TRAFFIC IMPACT STATEMENT

County Case Number: IUP-004-22

August 15, 2023
Revision #1: December 21, 2023

Public Works Traffic Engineering Review Comment Letter					
Project Name:		Rolling Plains Const. 5136 S. Desert View Dr., Apache Junction, Az			
Engineering Firm:		UCG		Reviewed by:	John Kraft
Engineer:		Sarah Simpson, P.E. , sealed 8/16/23			
Case #:	IUP-004-22	Review Status:	1 st Review	Date:	8/17/2023
RESPOND TO ALL COMMENTS AND REDLINES:

Figure 4: Sight Distance and Driveway Spacing

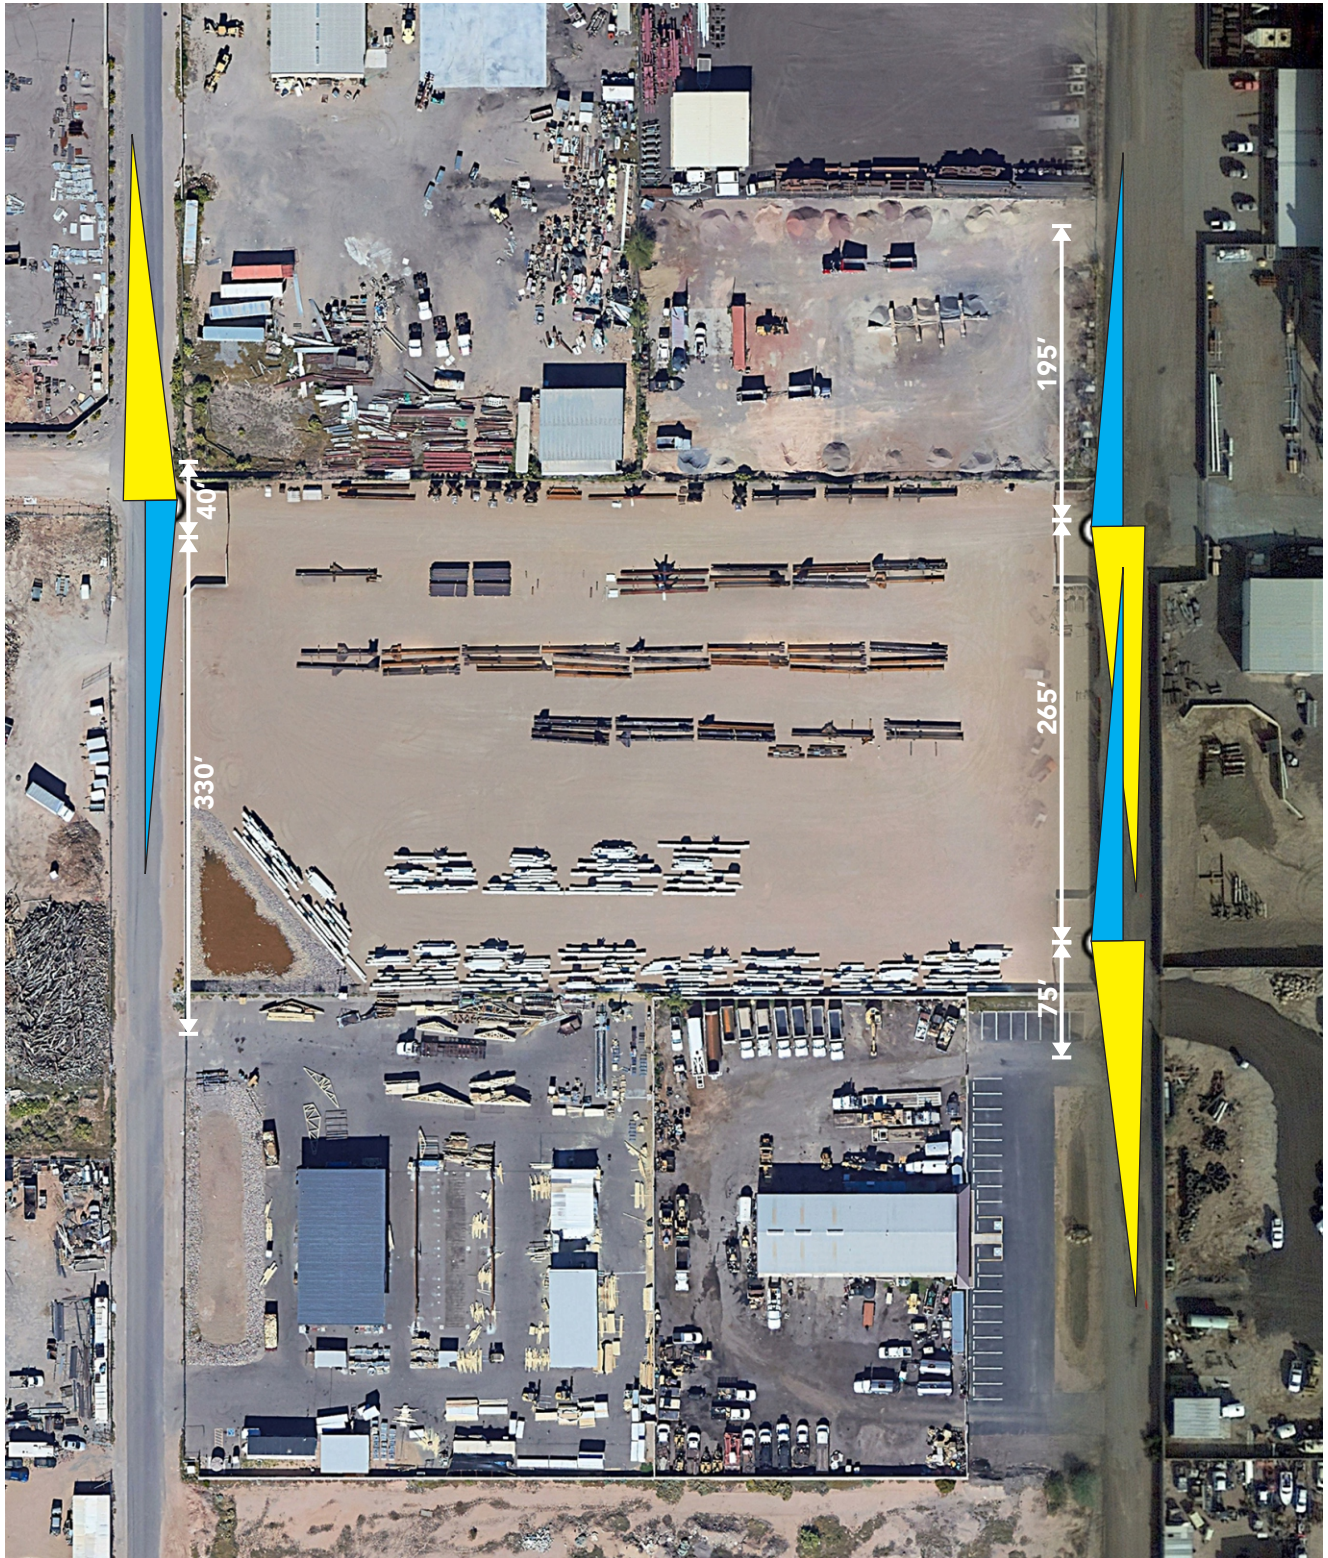
Page 4	9	Referencing Table 1, Please provide more information to show how the numbers in the Table were arrived at.			
Page 5	10	Referencing "clear view" IN 1 ST paragraph, Please show sight lines for each access on Site Plan.			
Page 5	11	Referencing "low Volume of vehicles", Please provide diagram for each access showing volumes.			
Page 5	12	Referencing "should" in 2 nd to last paragraph, Please commit to installing R1-1 by developer.			
Page 5	13	Referencing "40 feet apart" in last paragraph, Please show dimensions on Site Plan.			
Page 5	14	Referencing 4 th paragraph, "shall be provided" Please show sight lines or triangles on Site Plan or other diagrams in this report.			
Page 5	15	Referencing 5 th paragraph, "A Stop sign should be" change to "Will be installed with this project".			
Page 5	16	Referencing 6 th paragraph, "evaluation may not remain valid" change to read "evaluation should be revised and resubmitted for approval by Pinal Public Works Department."

Sheet No	Comment	Response
Cover Sheet	1	Added IUP-004-22 to cover
3	2	The expansion solely includes one parcel as shown on the site plan.
3	3	Removed from description because the parcel is between Warner Drive and Pinal Drive.
3	4	Laydown yard is now shown as the only parcel for the development in Figure 2 and within this report.
3	5	Driveway spacing is shown on Figure 4.
4	6	Recommended adding speed limit sign R2-1 on Warner Drive
4	7	Recommended adding R1-1 for the northbound approach on Warner Drive at Houston Avenue
4	8	Arrows are not required for local streets
4	9	The Trip Generation Manual was used for Manufacturing (140) for the laydown yard.
5	10	Sight lines shown on Figure 4.
5	11	Diagram provided showing trips into and out of laydown yard
5	12	Agree. Developer to install R1-1
5	13	Driveway dimensions shown on aerial view, Figure 4
5	14	Sight triangles shown on Figure 4.
5	15	Changed to will be installed for this project
